Access Compliance Report Public Rights-of-Way (Curb Ramps)

Intersection ID: 21461 Main Street: FOREST_POINT_BV Cross Street: W_ARROWOOD_RD Location: SE

ADA ID: 079F335371EF Ramp Type: PerpDiag Initial Pass/Fail: Fail Overall Compliance: No Severity Score: 46.25

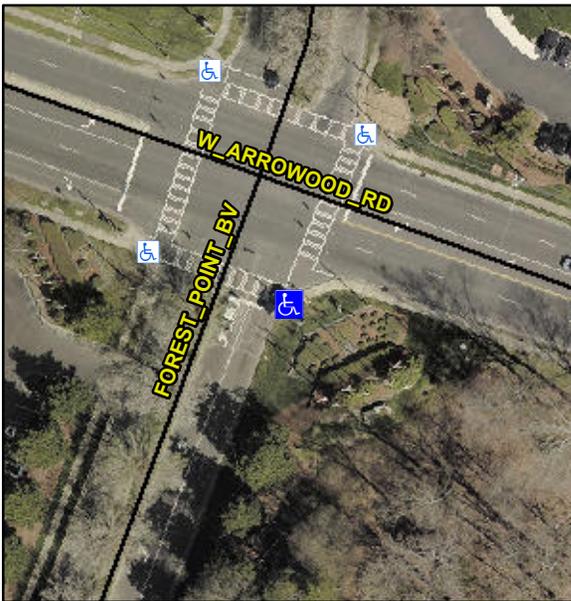
R304.5.1, R304.2.2, R304.5.3

Compliance	Description	Data	Compliance	Description	Data
N/A	Ramp Length (in)	60.0	No	Ramp Slope (%)	9.1
No	Ramp Width (in)	41.0	No	Ramp XSlope (%)	7.3
N/A	Flare Type LT	N/A	N/A	Flare Type RT	N/A
N/A	Flare Slope LT (%)	N/A	N/A	Flare Slope RT (%)	N/A
N/A	Flare Traversable LT?	N/A	N/A	Flare Traversable RT?	N/A
N/A	Landing Length (in)	N/A	N/A	DWS Provided?	N/A
N/A	Landing Width (in)	N/A	N/A	DWS Contrast?	N/A
N/A	Landing Slope (%)	N/A	N/A	DWS Length (in)	N/A
N/A	Landing X Slope (%)	N/A	N/A	DWS Full Width?	N/A
N/A	Landing Curb? (Y/N)	N/A	N/A	DWS Offset (in)	N/A
N/A	Shared Landing?	N/A			
N/A	Gutter Ponding?	N/A	N/A	Gutter Slope (%)	N/A
N/A	Gutter Lip Ht (in)	N/A	N/A	Gutter X Slope (%)	N/A
N/A	Painted X Walk1?	Yes	N/A	Painted X Walk2?	Yes
	X Walk 1 Direction	To NE		X Walk 2 Direction	To NW
N/A	X Walk 1 Width (in)	111.0	N/A	X Walk 2 Width (in)	111.0
	X Walk 1 Slope (%)	5.4		X Walk 2 Slope (%)	2.5
	X Walk 1 X Slope (%)	1.3		X Walk 2 X Slope (%)	5.0

Remove & Replace Curb Ramp With Two New Directional Ramps or Equivalent.
